Revision 02 - Section 96 Amendments

Site 68 Sydney Olympic Park

Elevation West

A05.02[02]

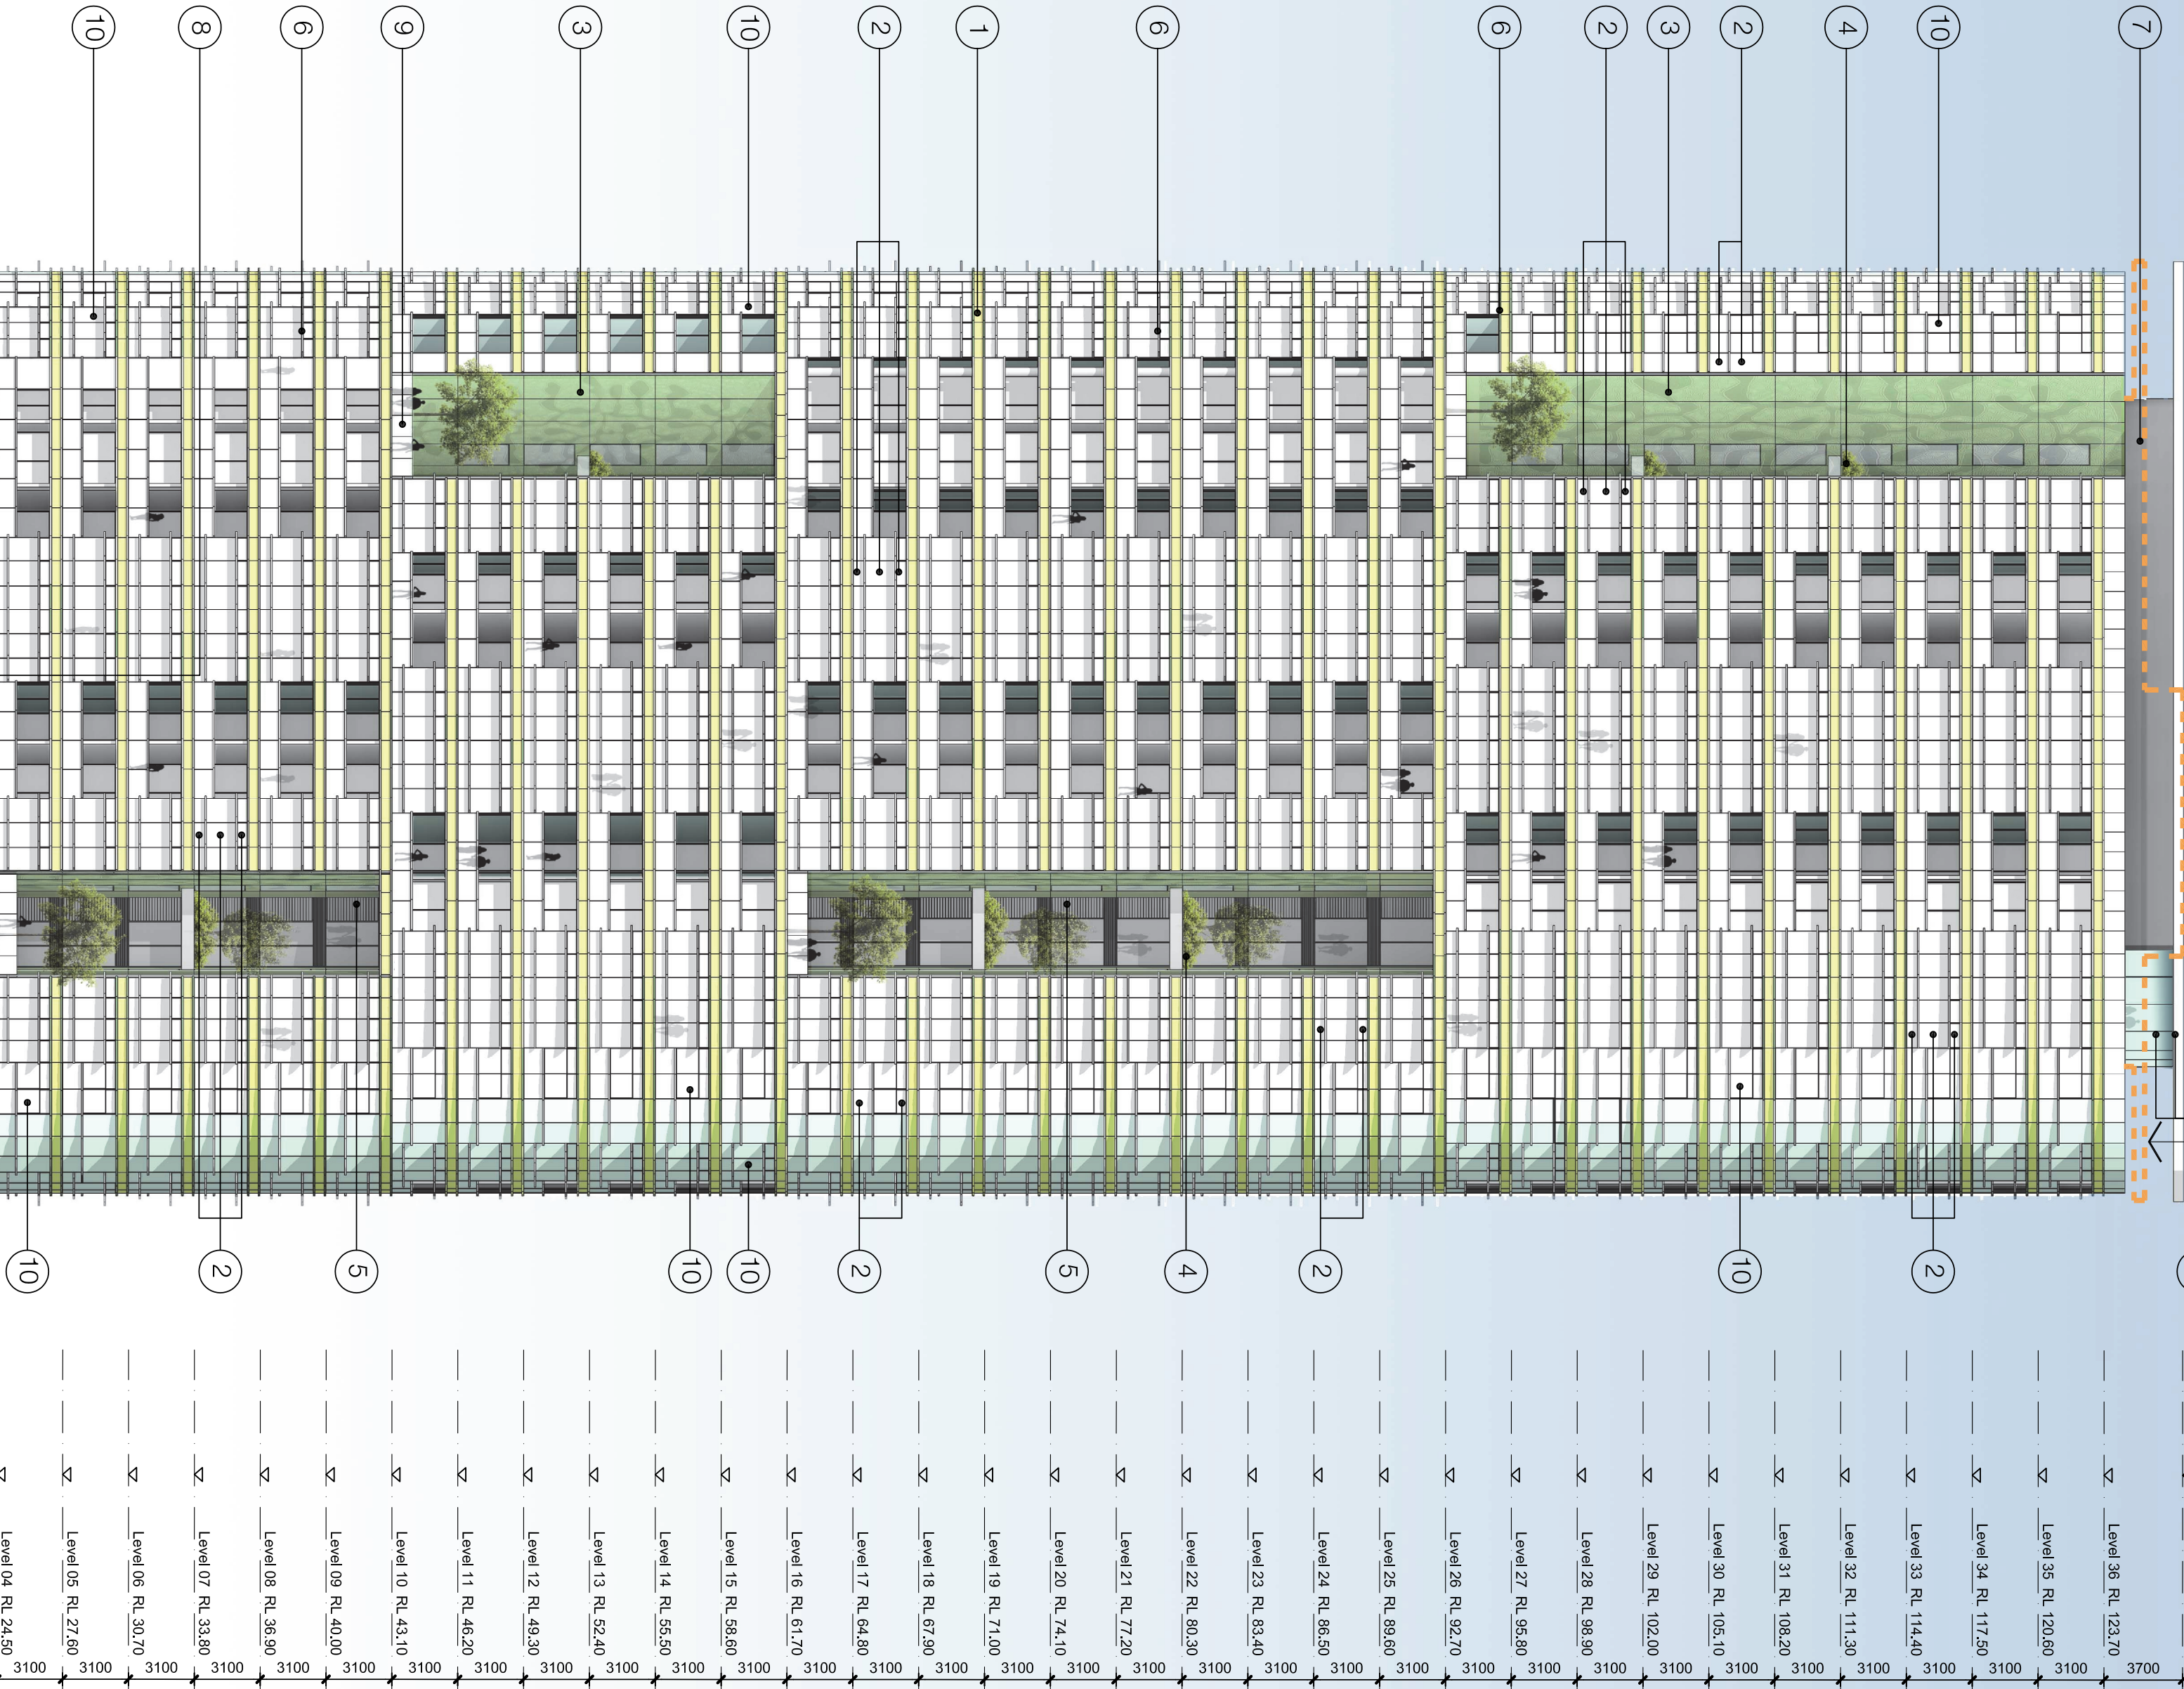
- A - Redesign to landscaped levels, lower lobby / RL lowered from 10.70 to 3.1m, lower typical floor to above height levels reduced from 5.5m to 3.1m.
- B - Excess plant space on rooftop converted to residential floors. New floor inserted at Level 35.
- C - New retail space inserted at level 25.
- D - Amendments to fitlines
- E - New retail tenancy within existing footprint at grade.
